T-1124

In the Matter of: ADVISORY COMMITTEE ON REACTOR SAFEGUARDS
SUBCOMMITTEE ON GRAND GULF

DATE: 11 August 1982 PAGES: 1 - 187

Figure 1. Recirculation Piping Isometric,
(General location of whip restraints
included.)

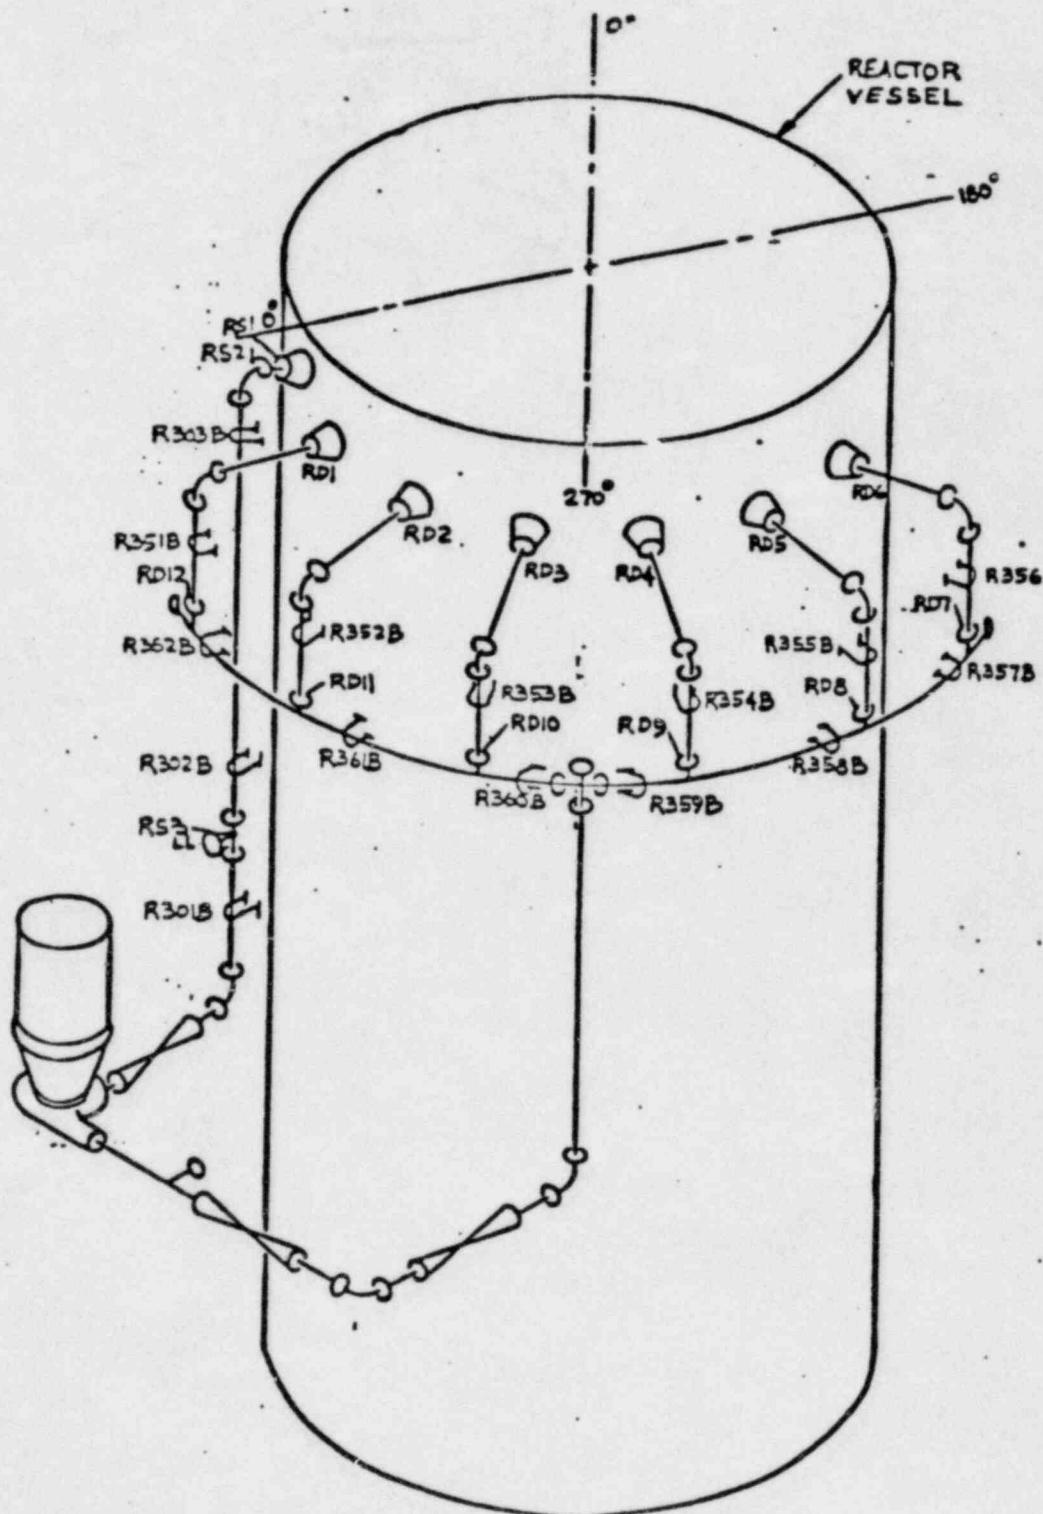
17 But they are not only lines with supports
18 supporting those bundles, okay, and that effect could
19 potentially -- if I remember right, there is a supporter
20 right in this area -- could impact one of the supports
21 for the CRD bundle. That is why we have got these pipe
22 whip restraints and the modification was made as a
23 result of that analysis, where this restraint was
24 tightened to ensure that there be no impact.

4 MR. EBERSOLE: So you are invoking the low
5 stress level as an escape route to deny the presence of
6 potential pipe splits that would provide a potential jet
7 to do this?

3 The other area that was looked into is, for
4 instance, this particular break here establishes a cone
5 this way, like that. Now in one particular case, in one
6 of the risers the bundles came down and, of course, they
7 had supports above and below. And the support was
8 modified.

9 MR. OKRENT: Let us see. I have heard, I
10 think, a few questions raised. One of the earlier one
11 related to whether in your looking at the possible
12 damage to these one-inch pipes you did or did not
13 include a full postulated range of pipe whip or full
14 postulated range of jets.

1 one modification made to the support as a result of that
2 pipe whip. In addition, originally the initial analysis
3 by GE said that there may be a longitudinal pipe break
4 right in -- along the header. That was a conservative
5 measure because the stress analysis had not been
6 completed. At a later time the stress analysis, when
7 completed, showed that in fact you would not have a
8 longitudinal break. Okay?

4 MR. RICHARDSON: That deformation was shown in
5 the testing done by GE to be up to 87 percent
6 deformation of a tube, and you still have the flow area
7 to provide the scram function of a rod.

12 MR. RICHARDSON: That is what the test
13 showed. Now in our analysis, we were more
14 conservative. We said that we would only allow 60
15 percent, if I am not mistaken. Somebody may correct me
16 if I am wrong.

Figure 3B-73. Loads at HCU Floor Elevation Due to Pool-Swell
Froth Impact and Two-Phase Flow

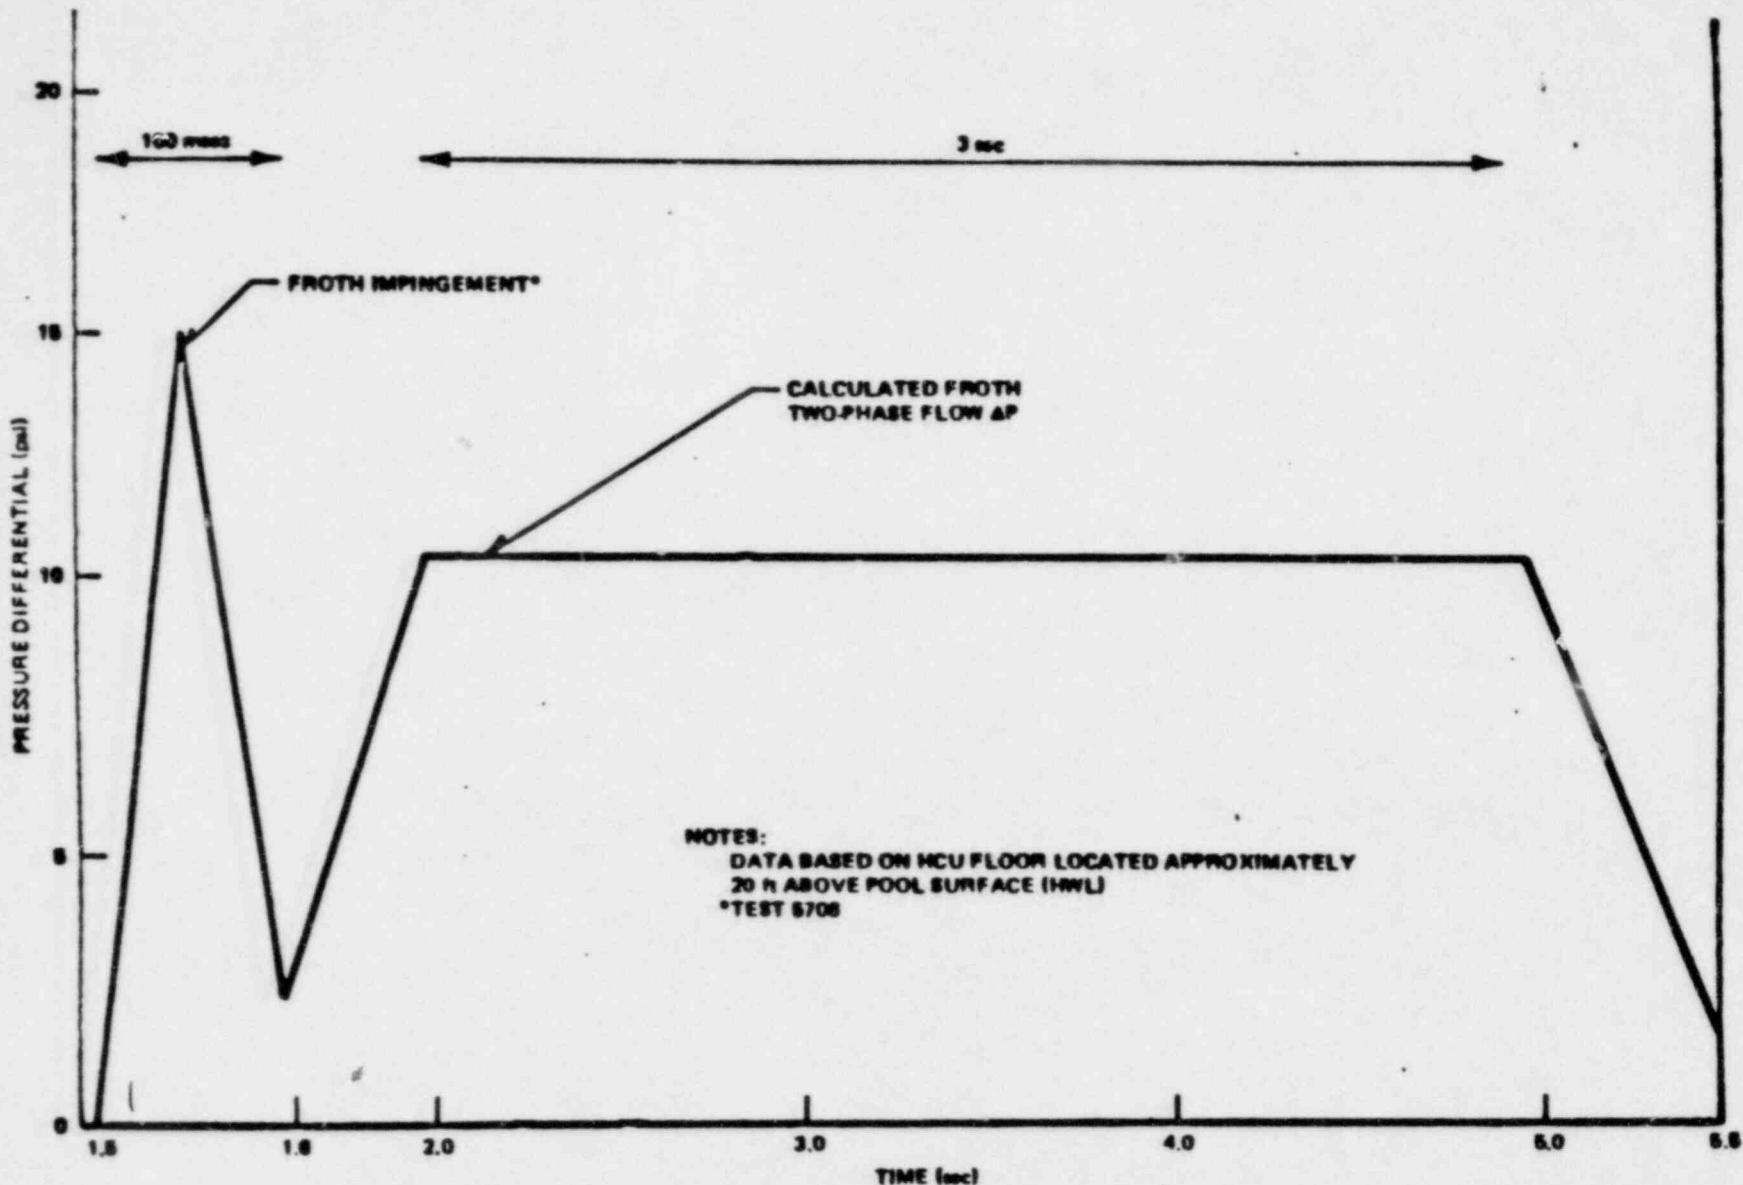
13 I might say that some of the concerns were
14 kind of interesting to a theoretician. The one that
15 stands out in my mind is the one about the effect of
16 intrusions into the air space above the water level in
17 the pool, when you get a bubble breaking through and
18 giving loads on structures like the HCU floor and so
19 on. The question is -- this was brought up by
20 Humphrey -- does this change the load on the hydraulic
21 control unit in an undesirable way?

3 And I think Jesse is very correct. I concur in it, that
4 the hydraulic control unit has to be intact after being
5 hit by this froth.

1 proceeded with a very interesting calculation of what
2 this intrusion would do. The motion of the bubble up
3 into the space above the undisturbed level of the pool,
4 whether the intrusion -- and the calculation is being
5 done by Dr. Tony Hurt, formerly of Los Angeles, now of
6 his own company. He is a very expert fellow in the
7 behavior of big bubbles like this in liquid, so it will
8 be interesting to see what he gets. My expectation is
9 that it will not be much different from what we already
10 have built into the plant as far as loads go.
